From: Ken Shimko <kshimko.meridianenv@gmail.com>
Sent: Monday, August 12, 2019 4:39 PM
To: Stoltz, Carrie R - DNR
Subject: Ladysmith Change Order - Install downgradient well nest, install/pump extraction wells to remove diesel LNAPL
Attachments: Change Order - revision 8-11-19.pdf

Change Order:

- **Abandon MW-102, PZ-100**
- **Install downgradient well nest (water table well, piezometer)**
- **Install 3 extraction wells**
- **Pump extraction wells with vac truck weekly for 6 weeks**

Autostop (former)
119 W. 9th Street North
Ladymith, Wisconsin 54848
BRRTS No. 03-55-282548
PECFA No. 54848-1295-19
Meridian No. 05F630

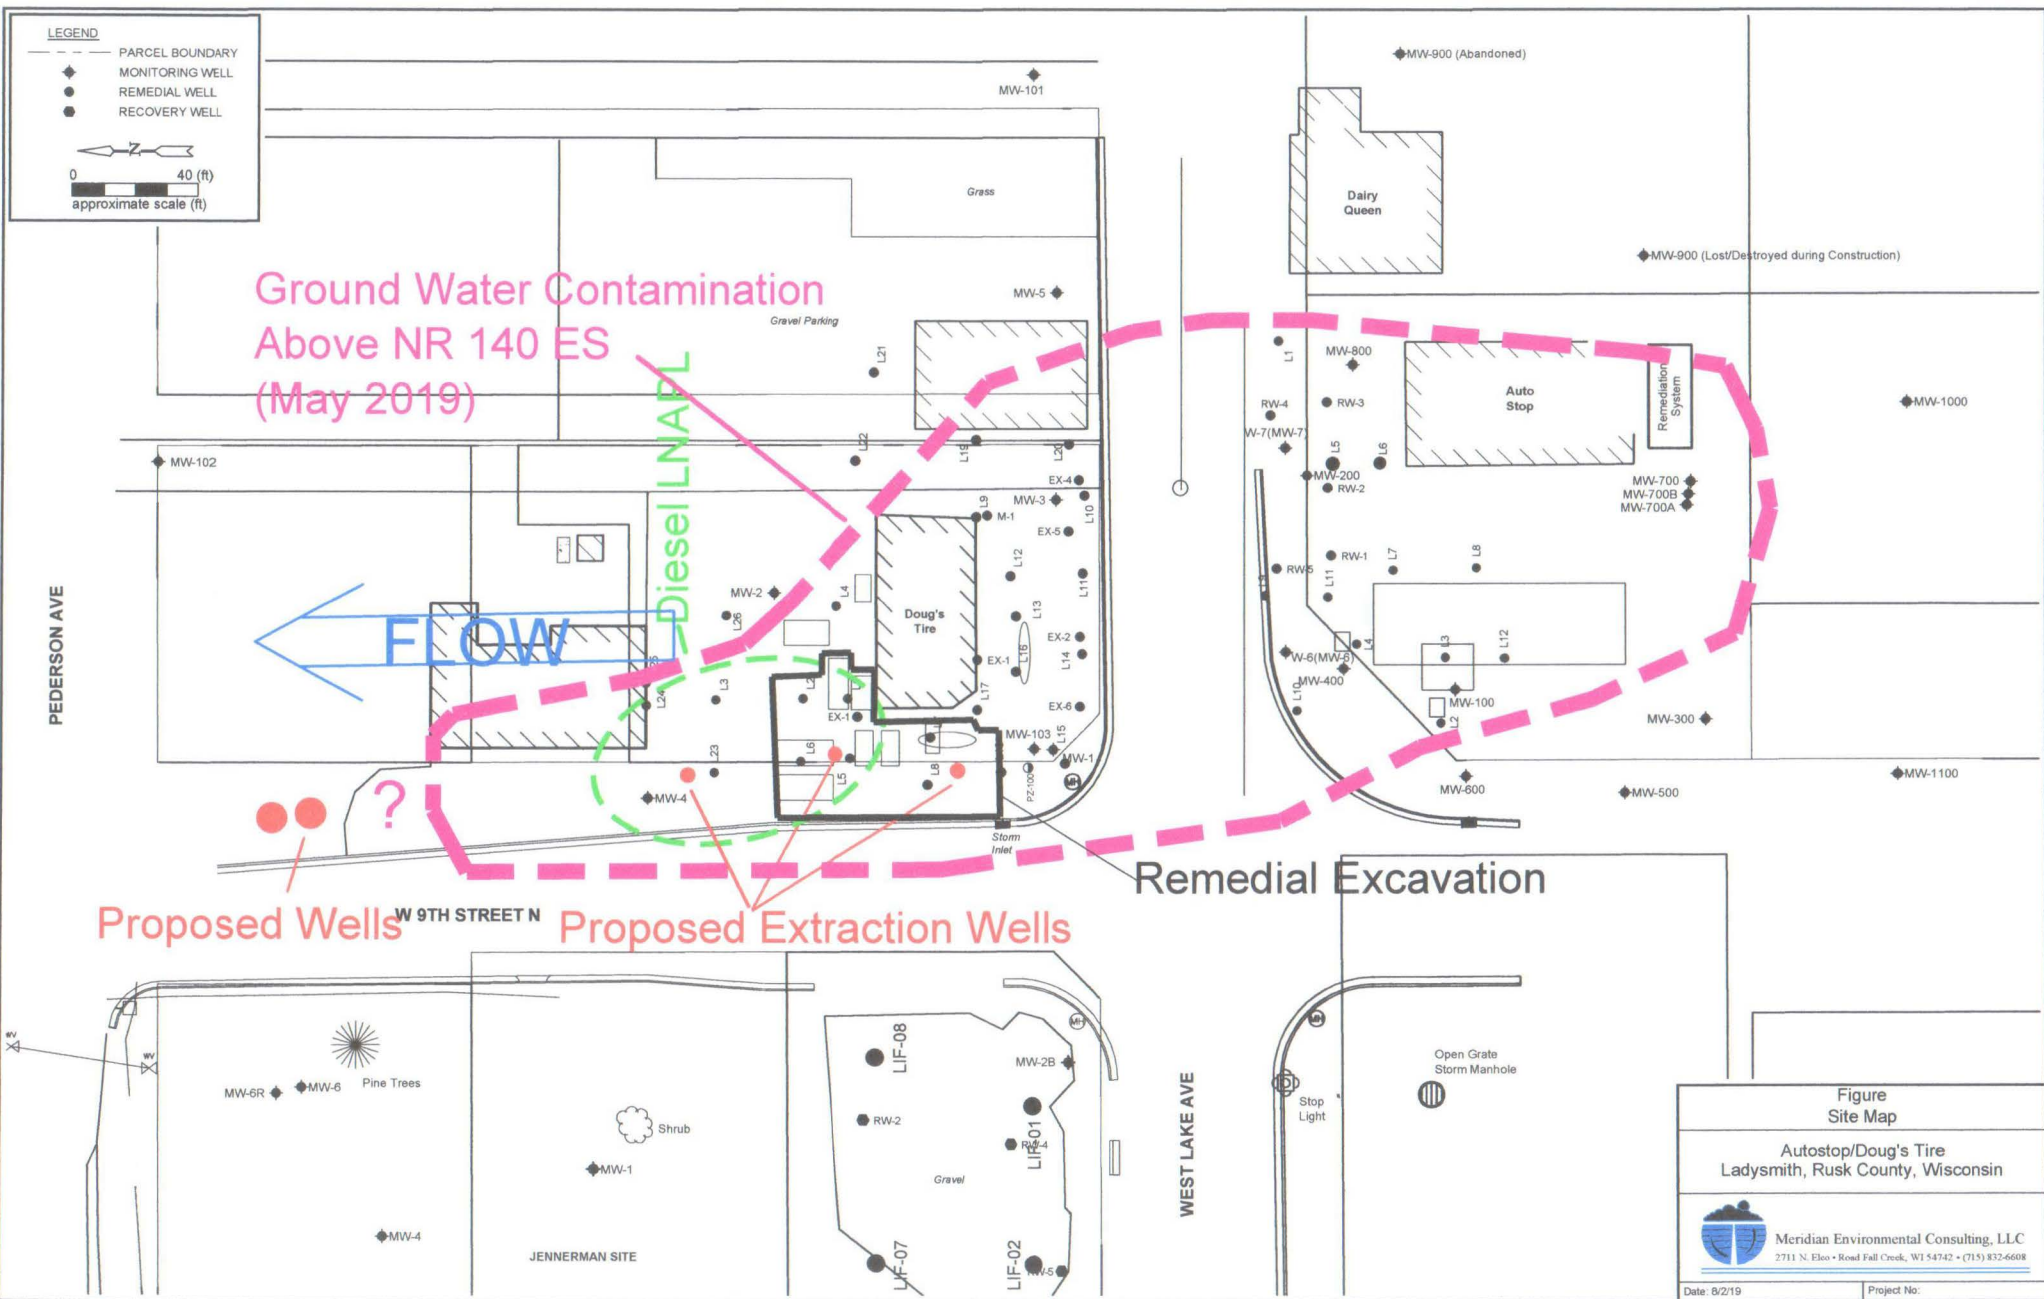
The extent of ground water contamination is not defined to the north. We recommend installing a well nest north of MW- 4 in the location shown on Figure 1. The water table well would be screened from 15 – 30 feet and the adjacent piezometer from 35 - 40 feet.

Diesel LNAPL was recently measured in MW-4. The LIF survey completed in 2012 identified diesel impacts at the smear zone in the northwest corner of the Doug's Tire property. The DNR recommended a remedial excavation as shown in Figure 1. The excavation was limited by the onsite building and Hwy. 27 (structural impediments).

We recommend installing three extraction wells (4 inch diameter) in the former remedial excavation (see Figure). The remedial excavation was backfilled with sand and diesel LNAPL may have accumulated in the coarse backfill material. The wells would be screened from 15 – 30 feet below grade and completed flush-grade. These extraction wells would be pumped weekly for 6 weeks using a vac truck. Monitoring wells MW- 4 and MW-103 would also be pumped during these weekly events.
